Modification Bulletin

MB Correction

Model: I/K Kit Type D for Azalea Da			Date	e: 15-Apr-97	No: 1	
Modified Article: Parts Catalog				Prepared by: A.Sasaki		
From: QAC 1st Field Information Dept.						
Reason for	□ Parts catalog correction	☐ Vend	☐ Vendor change ☐ To meet sta			
Modification:	☐ To facilitate assembly	☐ To improve reliability ())	
	☐ Part standardization	Other

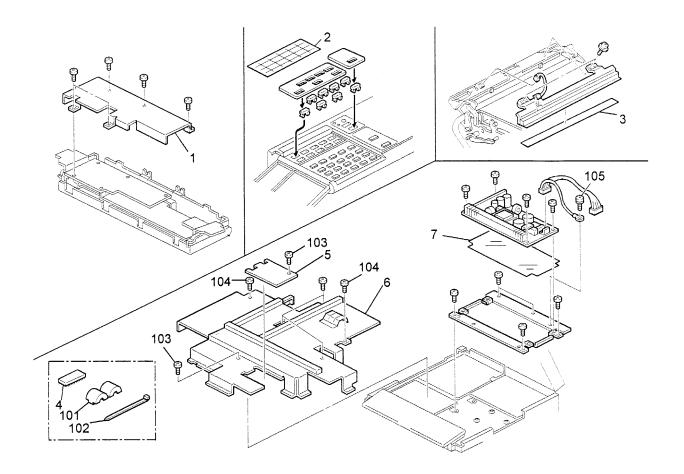
Please add the following parts and the illustrations to your parts catalog.

Old P/N	New P/N	Description	Q'ty	Parts Catalog		Reason
			Used	Page	Index No.	
	A6241221	EXU Shield Cover - Basic	0 → 1		1	To meet the EMI standard
	A6241306	Decal : Guidance	0 → 1		2	For other languages
	A1666164	Seal - PTL	0 → 1		3	P/C Correction
	A6245092	IC - Printer	0 → 1		4	P/C Correction
		(IC No. 238)				
	A6241215	Shield Cover	0 → 1		5	To meet the EMI standard
	A6241213	EXU Shield Cover - Edit	0 → 1		6	To meet the EMI standard
	AA150676	Sheet	0 → 1		7	P/C Correction
	16070623	Ferrite Core - TFC- 16-8-13	0 → 1		101	To meet the EMI standard
	11050042	Wire Band	0 → 2		102	To meet the EMI standard
	03140060B	Philips Pan Head Screw - M4x6	0 → 2		103	To meet the EMI standard
	03130080B	Philips Pan Head Screw - M3x8	0 → 2		104	To meet the EMI standard
	08010149	Philips Pan Head Screw - M4x6	0 → 1		105	To meet the EMI standard
